Interactive comment on “r.sim.terrain: a dynamic landscape evolution model” by Brendan Alexander Harmon et al.

Brendan Alexander Harmon et al.

Received and published: 15 May 2019

Fig. 1. Fig 2

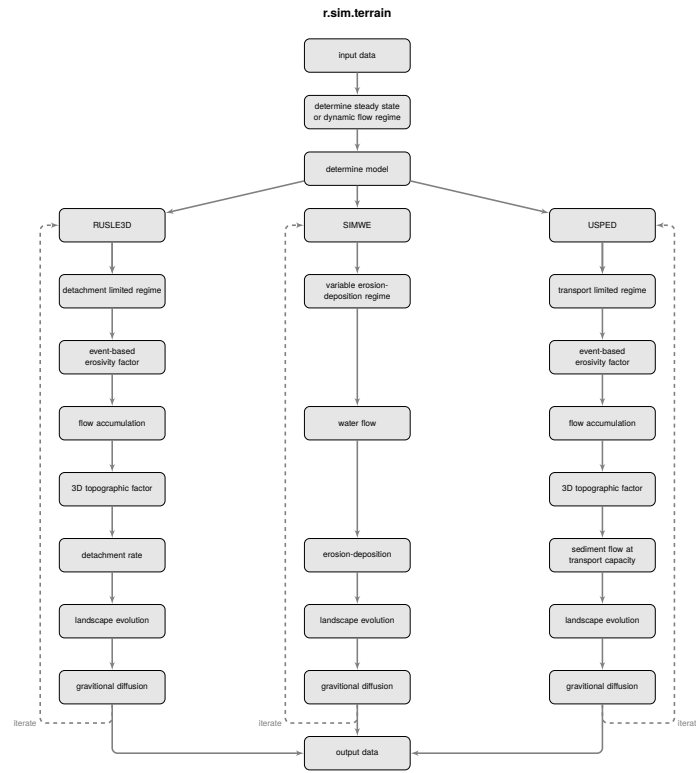
The text has detailed descriptions of the underlying theory behind many components of the overall simulation model (section 2) but does not indicate how these relate to one another. While there are many colorful figures of landscape evolution results, there is no representation of the model itself (e.g., UML or other flow-chart-like visualization) - nor is there much in the way of narrative description of how the model actually works to combine the described elements

We have added a conceptual diagram of the model as Figure 2.

Fig. 5. Fig 6

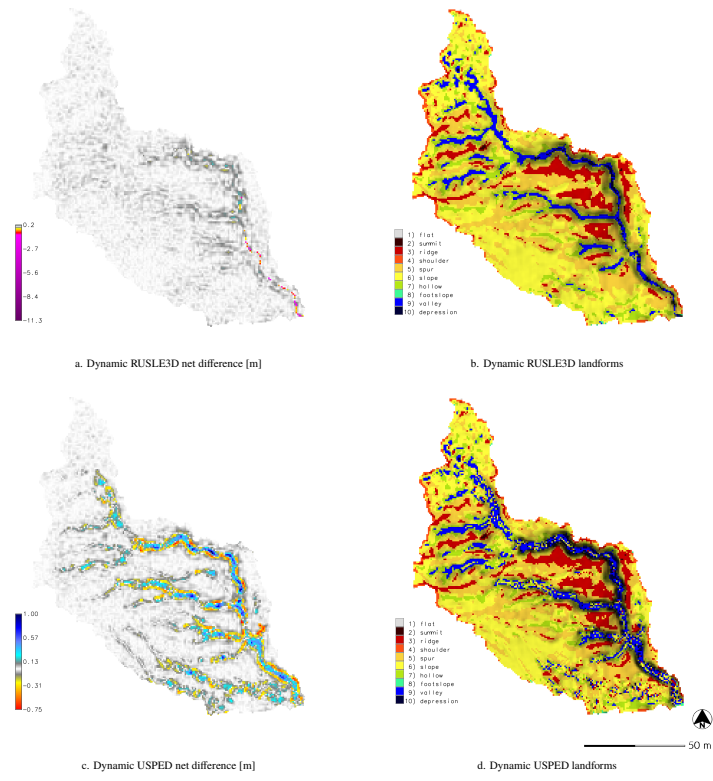
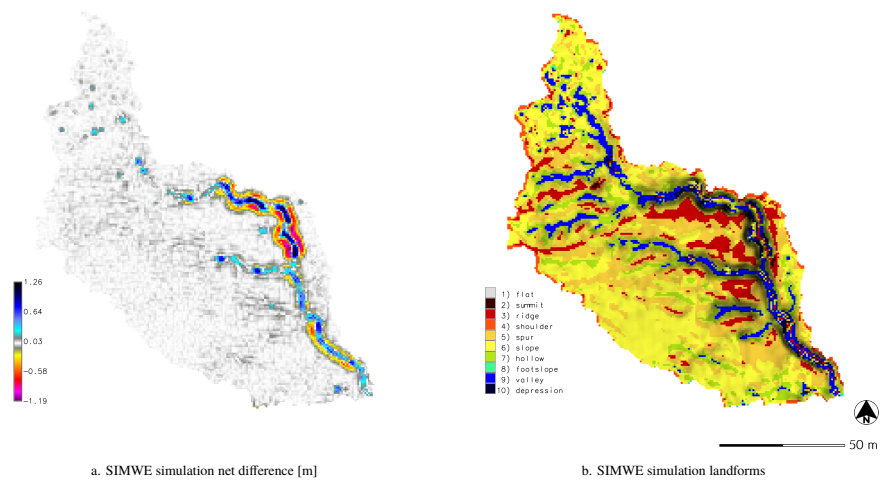
Figures 5 and 6: why the different color schemes in two of the three comparisons (top and bottom rows)?

Figure 6: if the figure is meant to compare runs with two different rainfall intensities, which intensity was used for the upper and middle figures?

We have redone these figures (now Figures 6-7). The left columns showing the net difference may appear different, but have the same color table. Since the detachment limited regime only has negative values, the upper range of the color table does not appear.

We have completely redone these figures, removed SIMWE's detachment and transport limited cases, and laid out the figures for more direct comparison.
